September 29, 1983

RE: Red Rock Mine Plan Review #2
S & S Mining Company
ACT/037/050
San Juan County, Utah

RE: Red Rock Mine Plan Review #2
S & S Mining Company
ACT/037/050
San Juan County, Utah

Proposed Pond Site
9-25-83
1" = 40'
Plan View

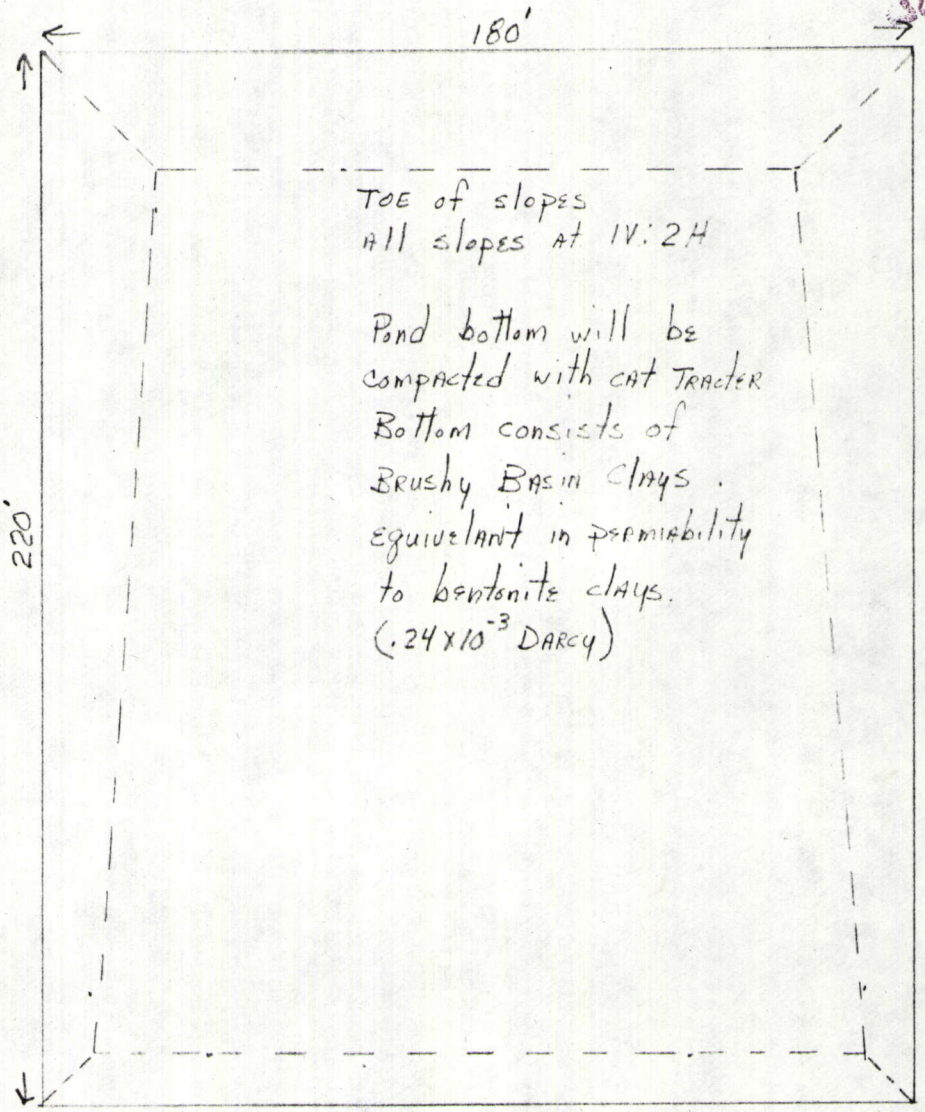
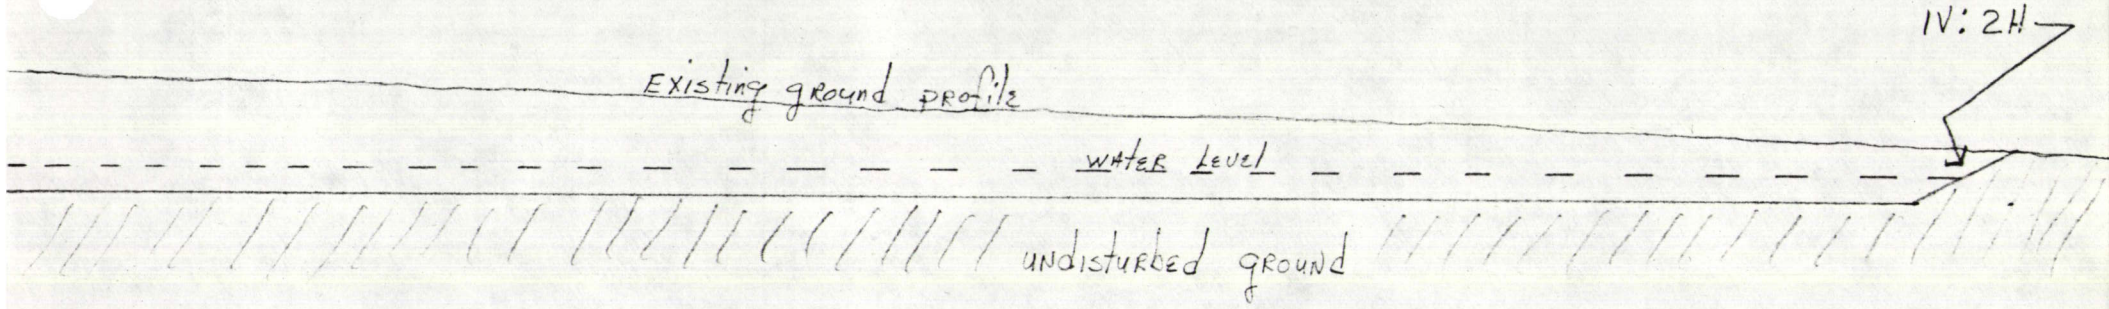
I am attaching herewith a new drawing and design showing that no dam as such is necessary and that the pond will adequately control all waste water.

With respect to the sketch presented and your comment that the dam should be revised to provide for a more stable structure, we believe that the new design that will be presented to you on September 30 will demonstrate that no dam is necessary and that the excavated pond will adequately control all waste water.

Note: No dams or embankments of disturbed soil to be used. All containment walls of the pond will be existing undisturbed clays.
